This document reports on a design mistake found on PCB layout of the LCD controller board (part # LVC75Z779 Eval Board Version 1E) and suggests a remedy for it.

Figure 1 0.1uF 0603 decoupling cap required for pin 32

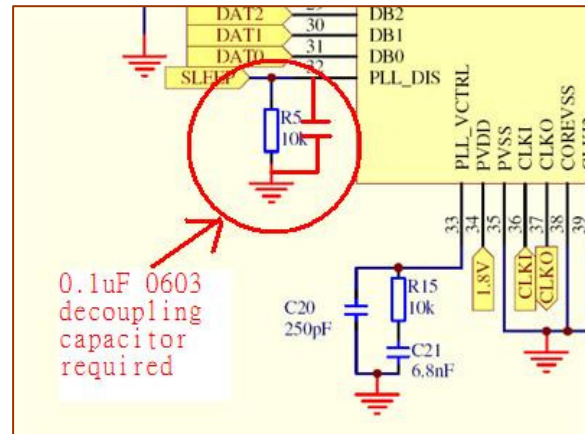
Figure 1 shows an extract of the schematic. Pin 32 of SSD1928 is the PLL disable pin (PLL_DIS) for power down. The original design includes a 10k shunt to GND and this pin is wired to Pin 36 of JP1 for microcontroller.

A 0.1uF 0603 decoupling capacitor is required for this pin.

Please locate R5 on the component side as shown in Figure 2. Solder a 0.1uF 0603 ceramic capacitor on top of R5 (no R5 remove required). This action will greatly improve the stability.
